ADDENDUM NO. 1

RED CLAY CONSOLIDATED SCHOOL DISTRICT
WILLIAM F. COOKE, JR ELEMENTARY SCHOOL
2025 Graves Road, Hockessin, DE 19707

THE WHITING-TURNER CONTRACTING COMPANY
CONSTRUCTION MANAGER
131 Continental Drive – Suite 404
Newark, DE 19713
302-292-0676 (phone)
302-292-0683 (fax)

SEWER DETAIL TABLE

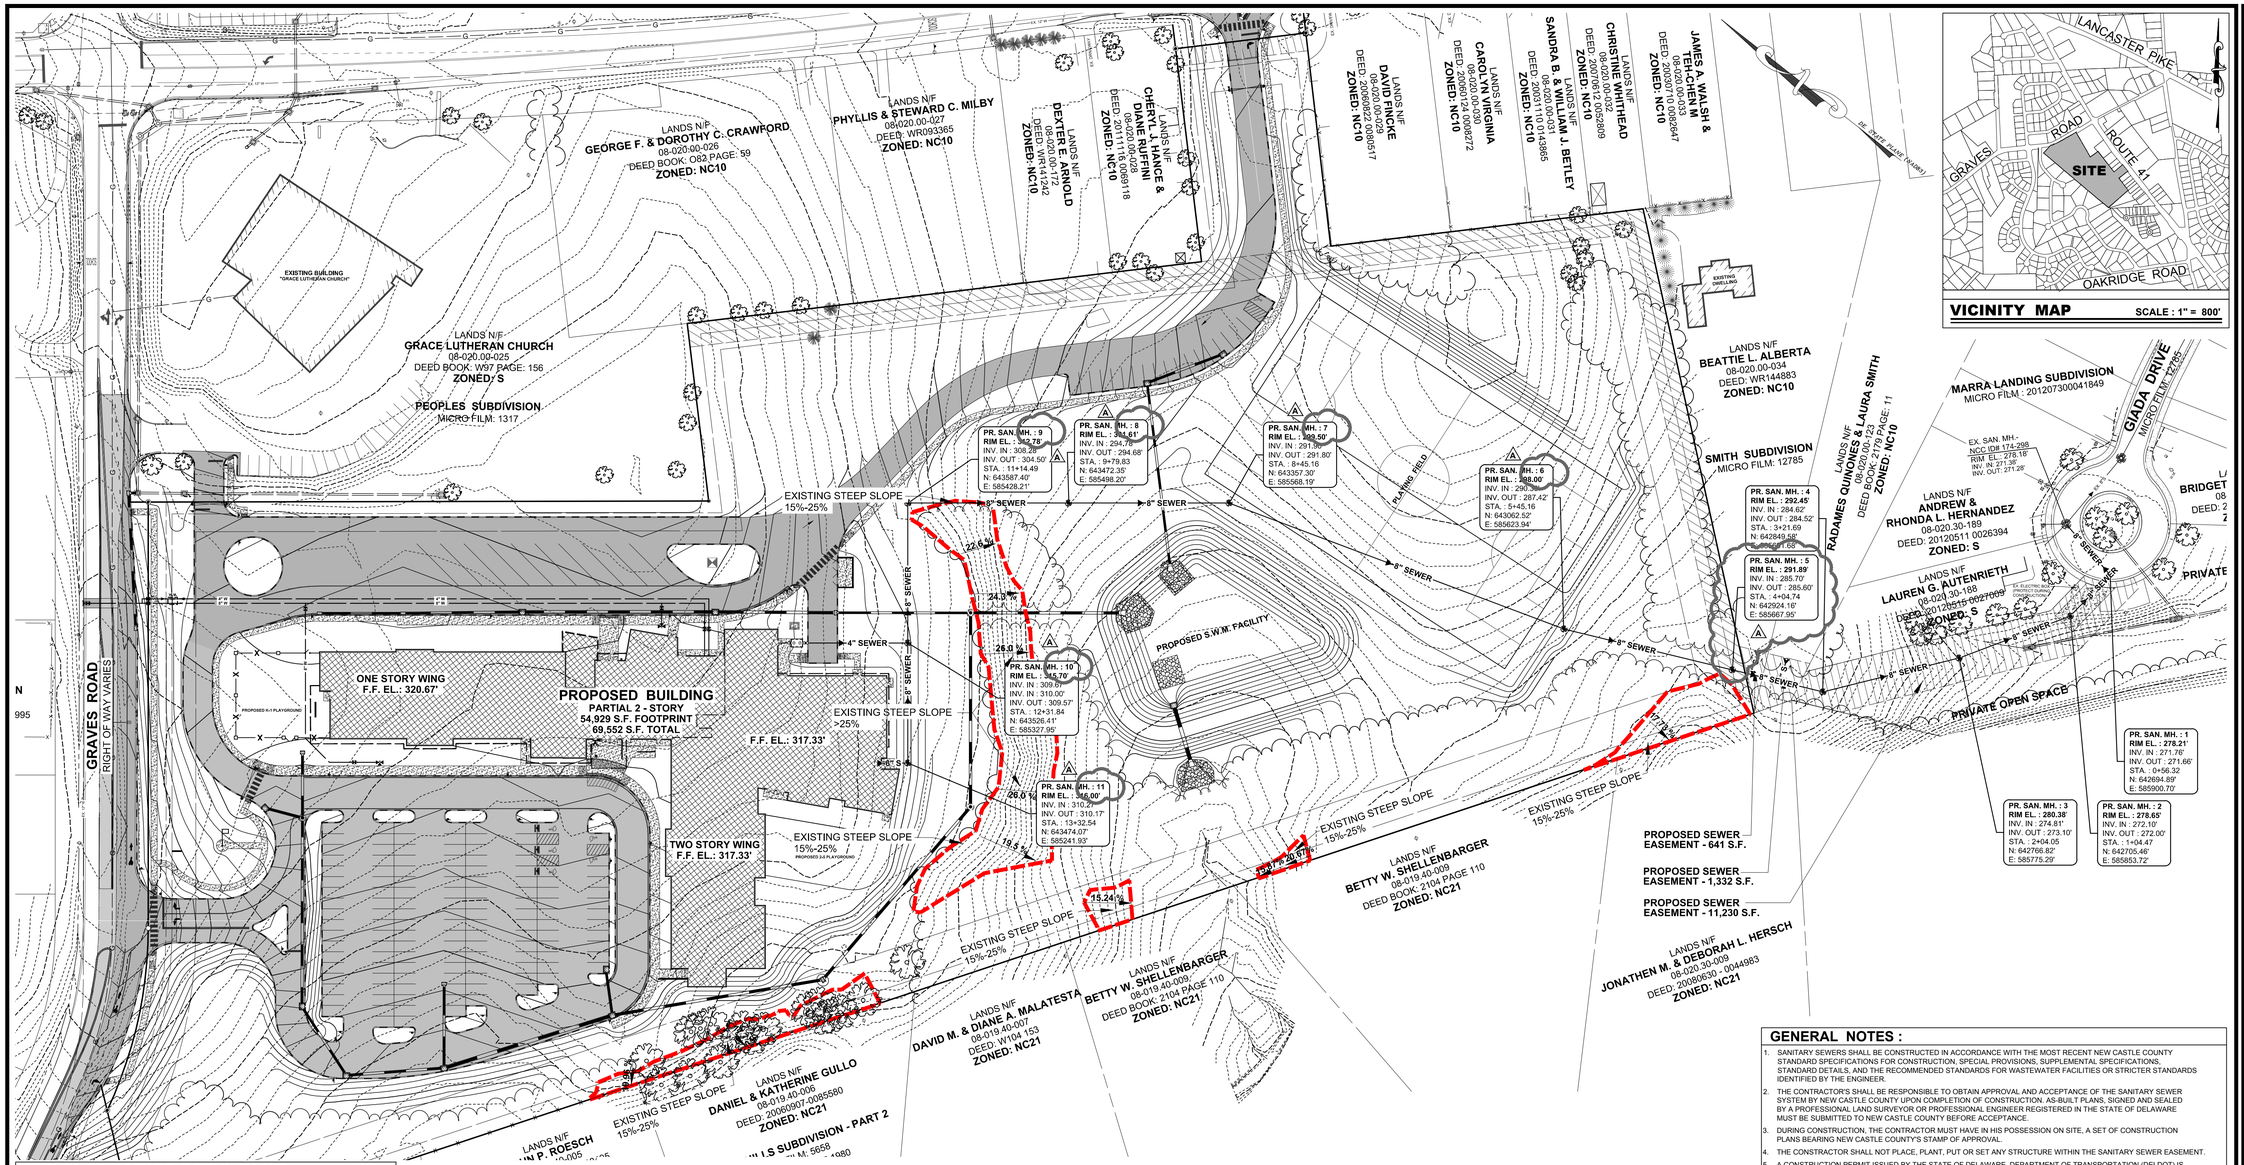
3.5 DRAWING C-300 UTILITY COVER SHEET
3.5.1 REPLACE Drawings C300 with drawing issued in this addendum.
3.5.2 REVISED "Total Number of Manholes" from 10 to 11 in the Sewer Detail Table on sheet C-300.

SANITARY SEWER PROFILE - STATION 0+00 TO STATION 8+75

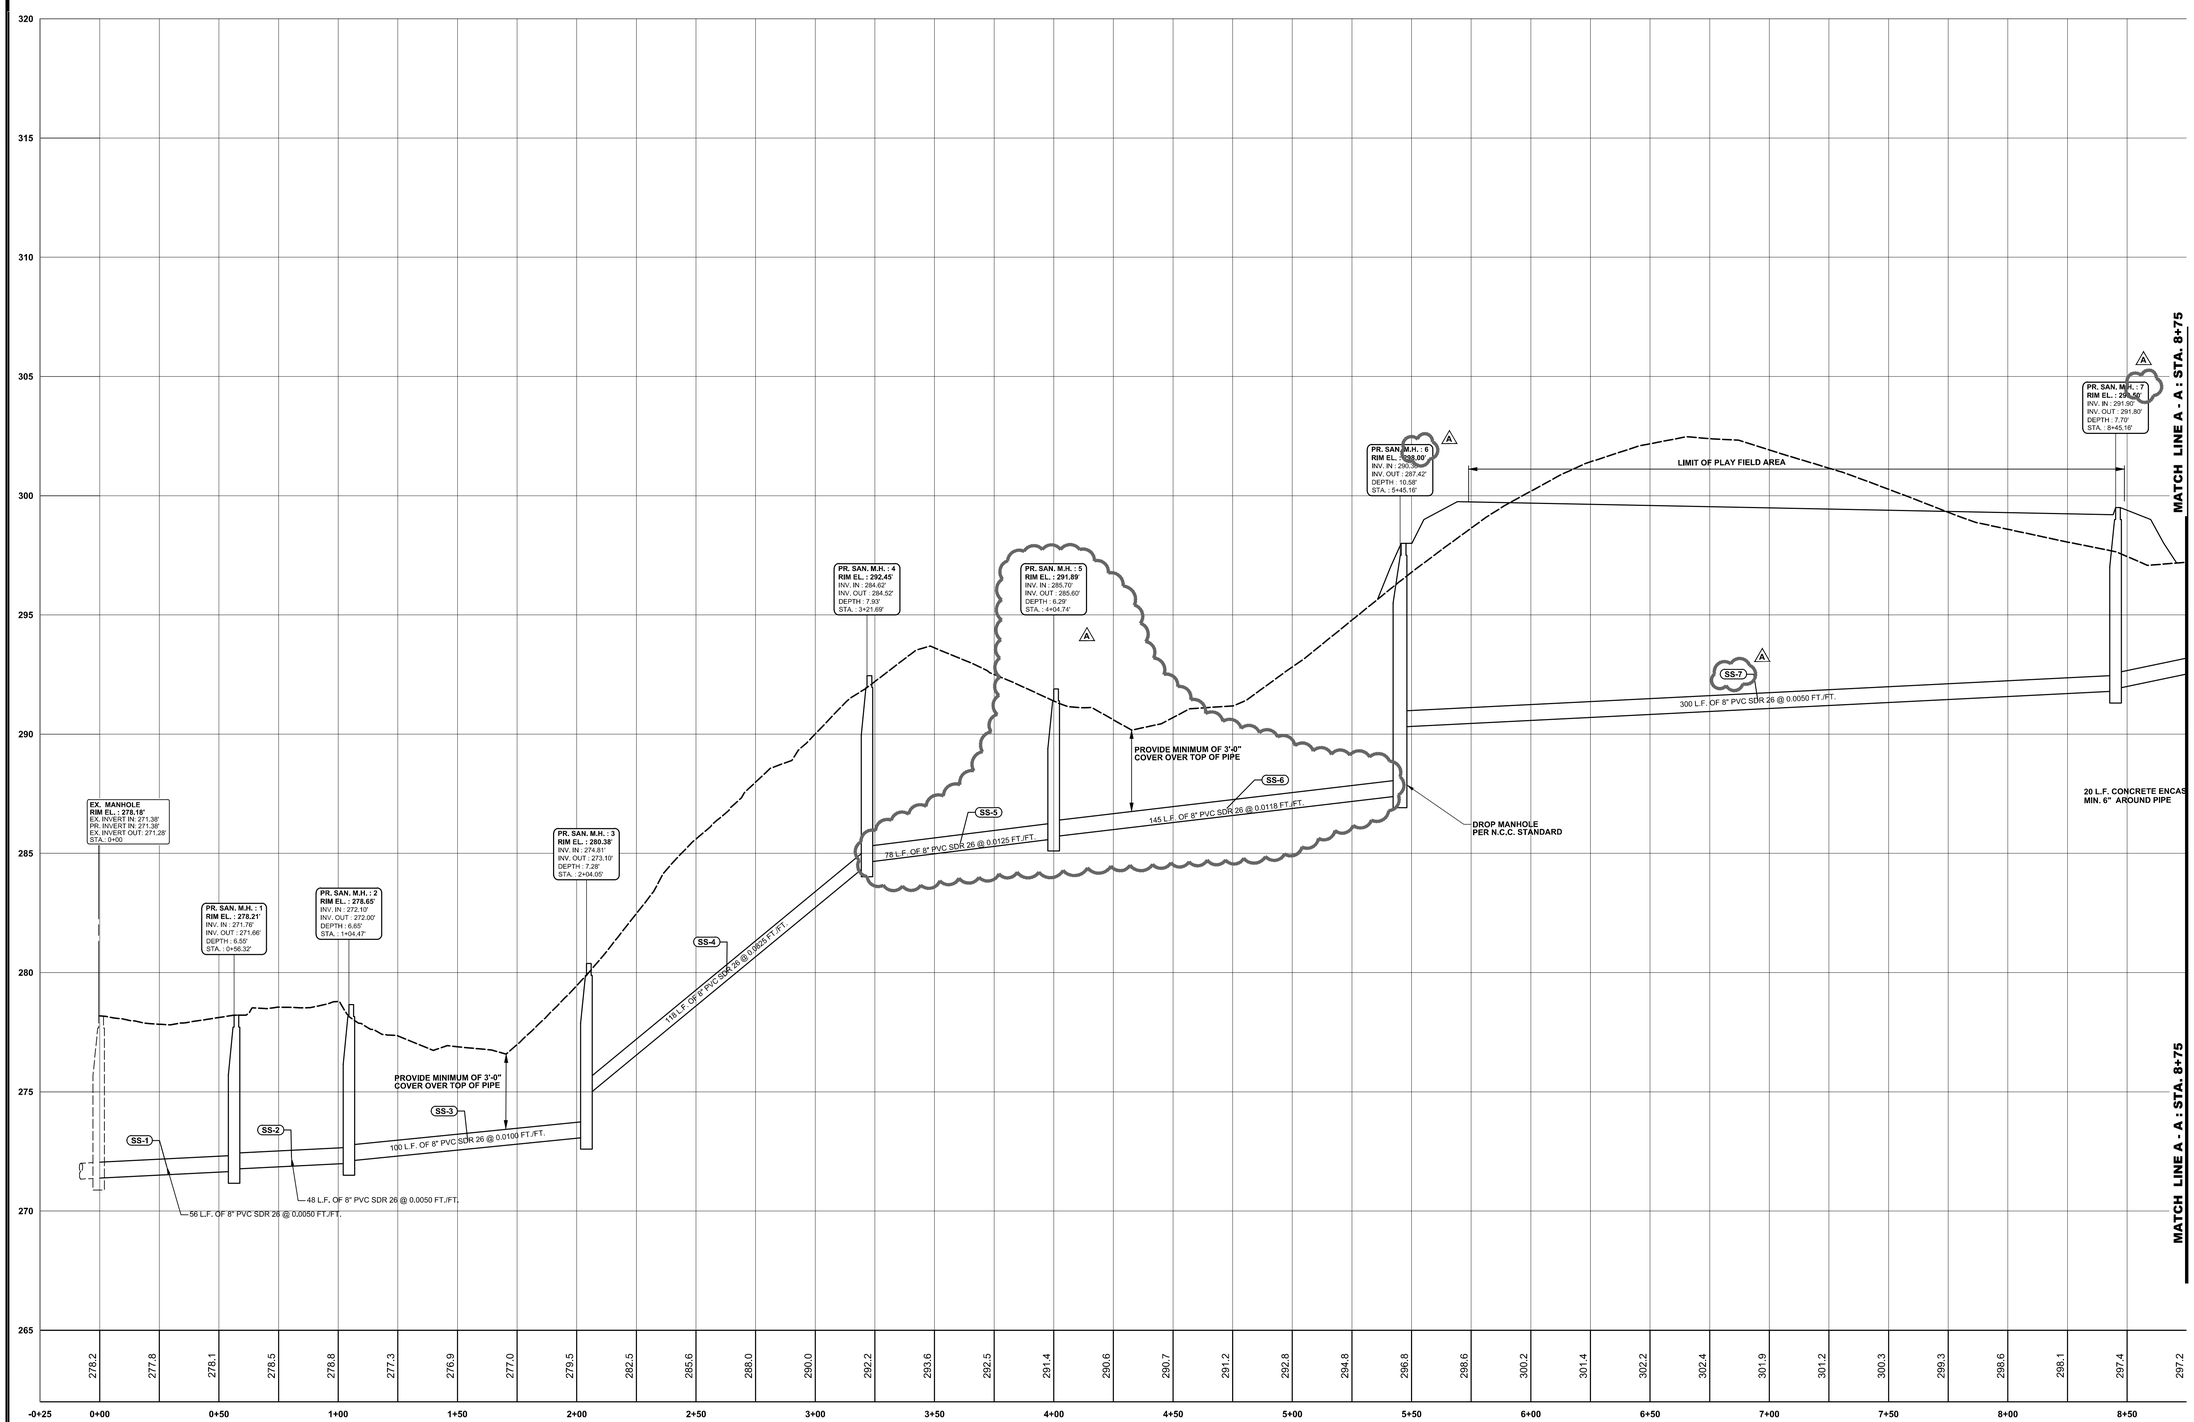
3.18 DRAWING C-701 SANITARY SEWER PROFILE
- 3.18.1 REPLACE Drawings C701 with drawing issued in this addendum.
- 3.18.2 Add new manhole and label (new San. M.H. 5) in profile.
- 3.18.3 Manholes previously labeled as San. M.H. 5 and San. M.H. 6 have been renumbered to San. M.H. 6 and San. M.H. 7.
- 3.18.4 Sanitary Sewer Pipe previously labeled as SS-5 has now been bisected by new manhole #5 creating new pipe SS-5 and SS-6. Previously labeled pipe SS-6 has been renumbered as SS-7.
- 3.18.5 REPLACE Drawing C701 with drawing issued in this addendum.
- 3.18.6 REVISE Sanitary Sewer Manhole #3 from 48” diameter to 60” diameter and manhole becomes a drop manhole. Invert In elevation revised to el. 276.00.
- 3.18.7 REVISE Sanitary Sewer Pipe #SS-4 slope and invert.
- 3.18.8 ADD “Public/Private” Text and arrows at manhole #5.

SANITARY SEWER PROFILE - STATION 8+75 TO STATION 13+02.28

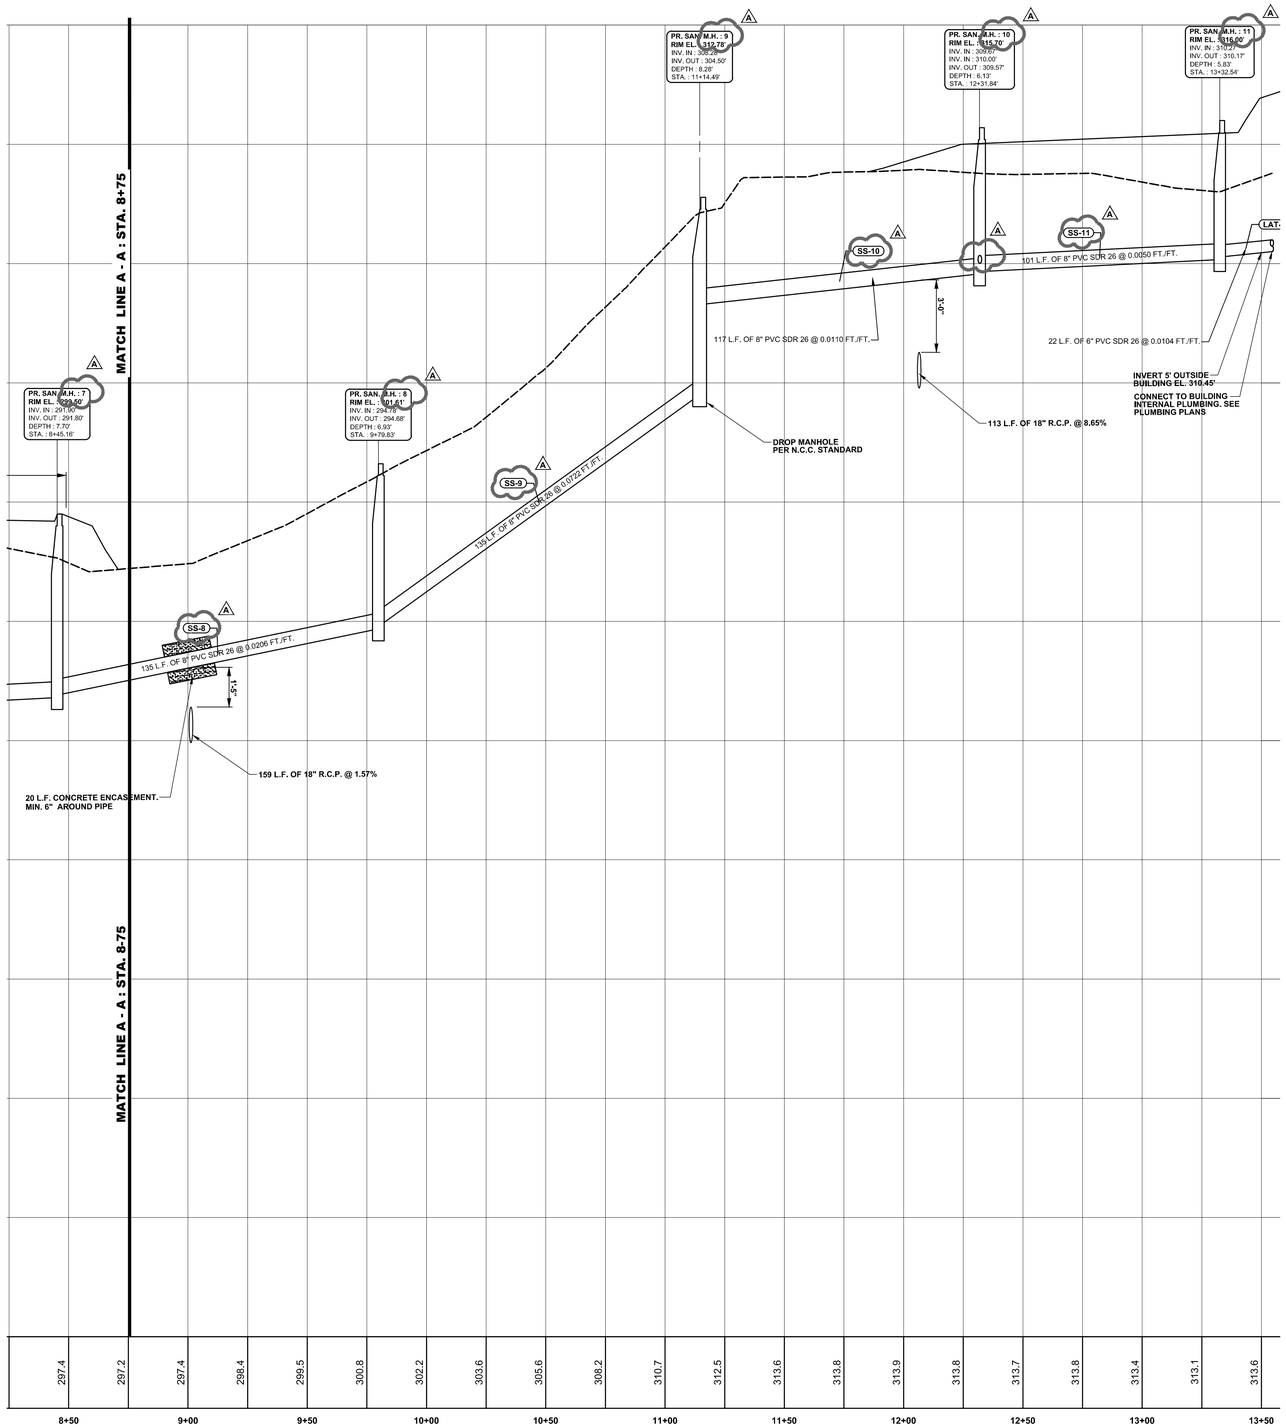
3.19 DRAWING C-702 SANITARY SEWER PROFILE
- 3.19.1 REPLACE Drawings C702 with drawing issued in this addendum.
- 3.19.2 Manholes previously labeled as San. M.H. 6 through San. M.H. 10 have been renumbered to San. M.H. 7 through San. M.H. 11.
- 3.19.3 Previously labeled pipes SS-7 through SS-10 have been renumbered as SS-8 through SS-11.
- 3.19.4 Added Lateral 2 in cross section of San. M.H. 10 (as relabeled, previously M.H. 9) in Sanitary Sewer Profile – Station 8+75 to 13+02.28.

CSK001

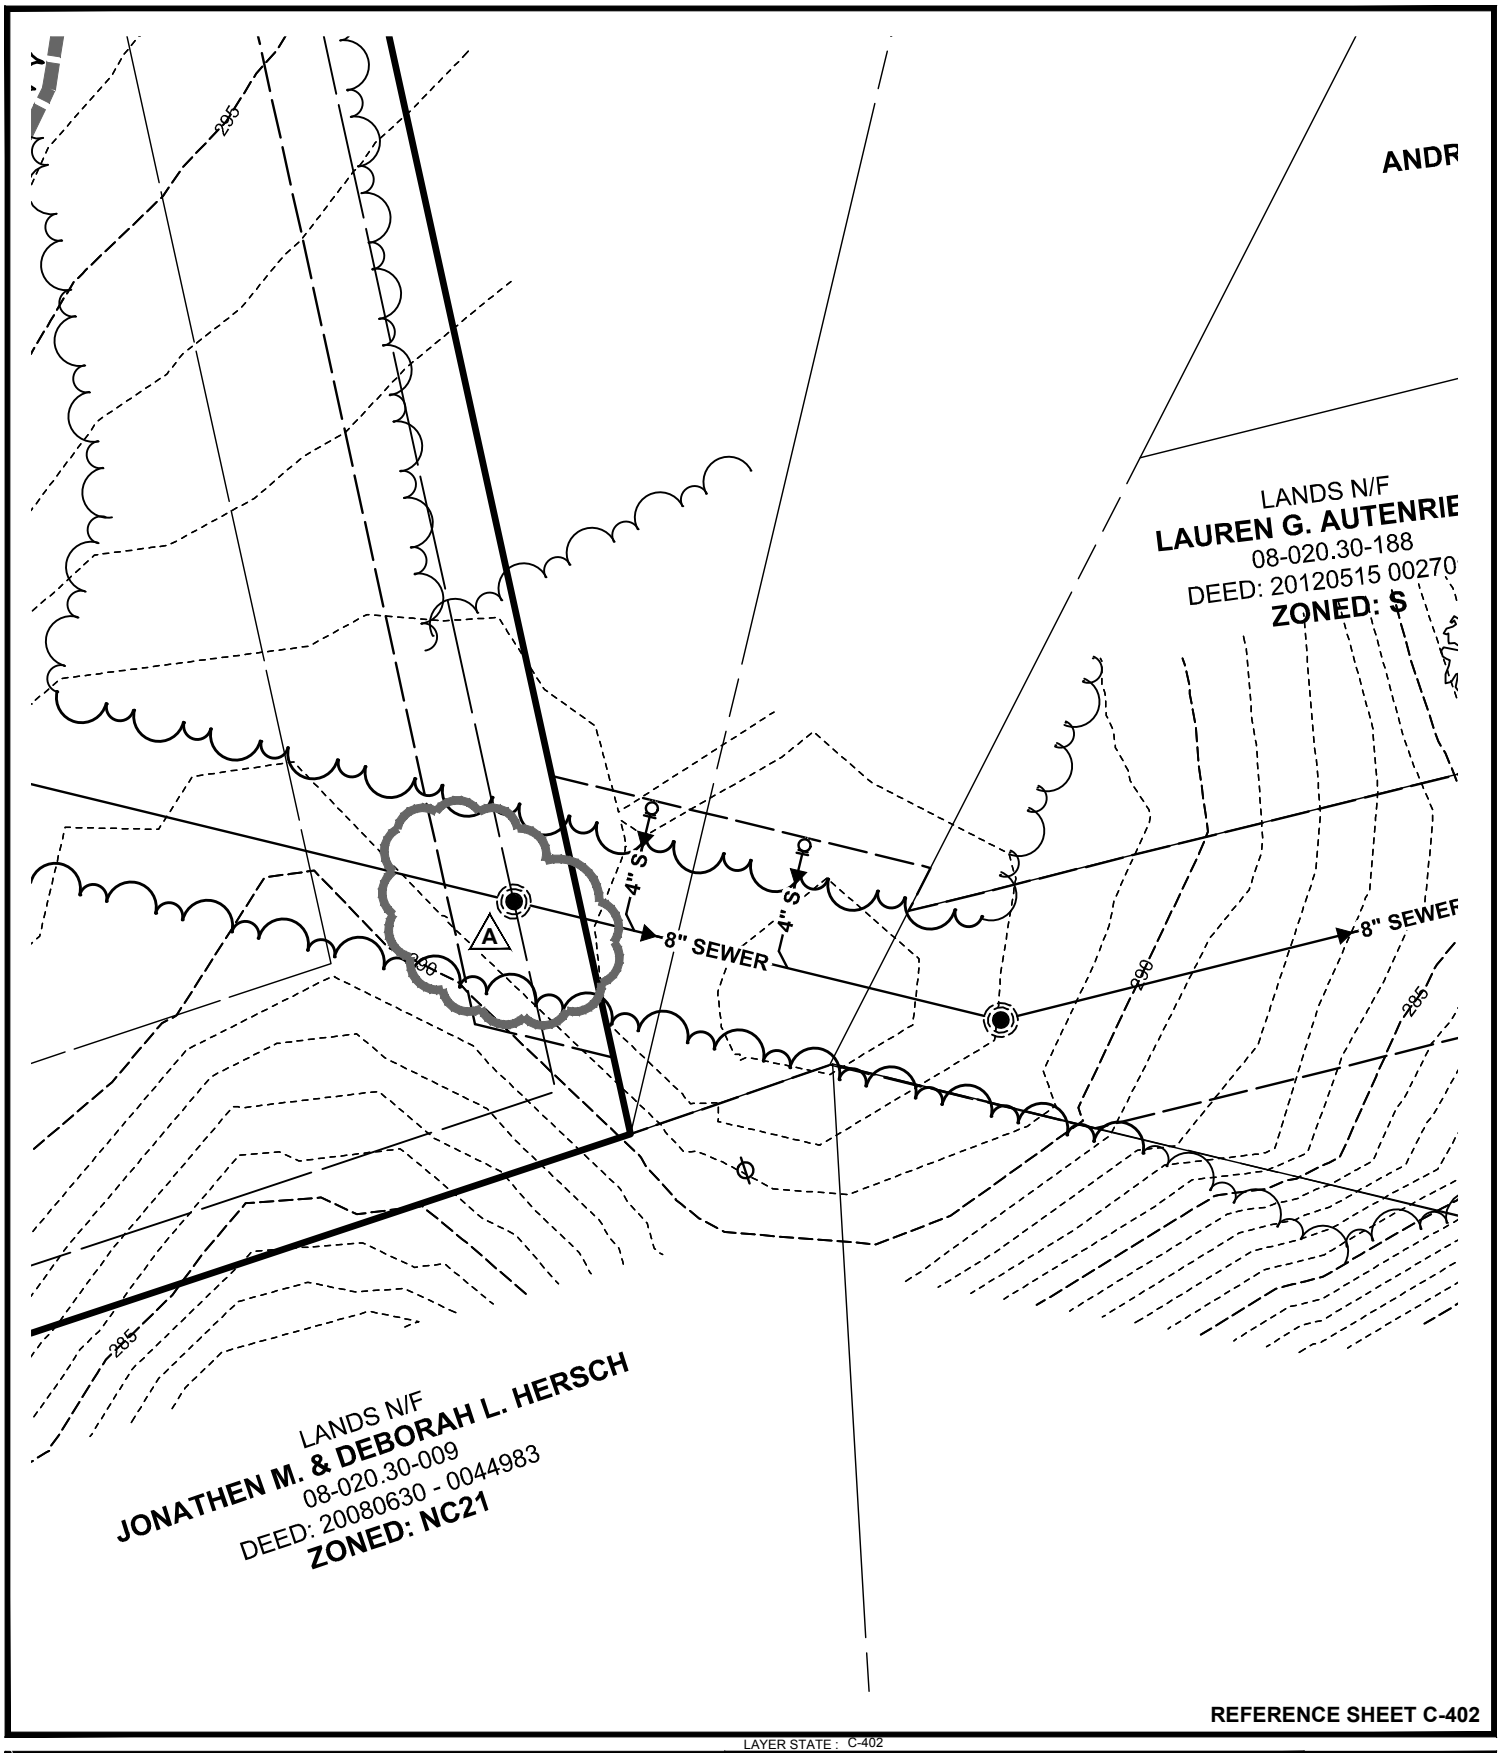
3.9 DRAWING C-401 GRADING PLAN
3.9.1 ADD new manhole (new San. M.H. 5) at southwest corner of property where sanitary sewer system enters from the adjacent property. – See sketch CSK-001.
3.9.2 REVISE proposed new edge of wooded area at northwest corner of property along Graves Road (adjacent to Galster Property) per attached sketch CSK007.
3.9.3 REVISE grading at northwest corner of property along Graves Road (adjacent to Galster Property) per attached sketch CSK007.
3.9.4 ADD condensate drain connection to roof drain piping and construction note label per attached sketches CSK025 and CSK026.
3.9.5 REVISE storm drain construction notes to include D-9, concerning connection of condensate drain to roof line per attached sketches CSK025 and CSK026.
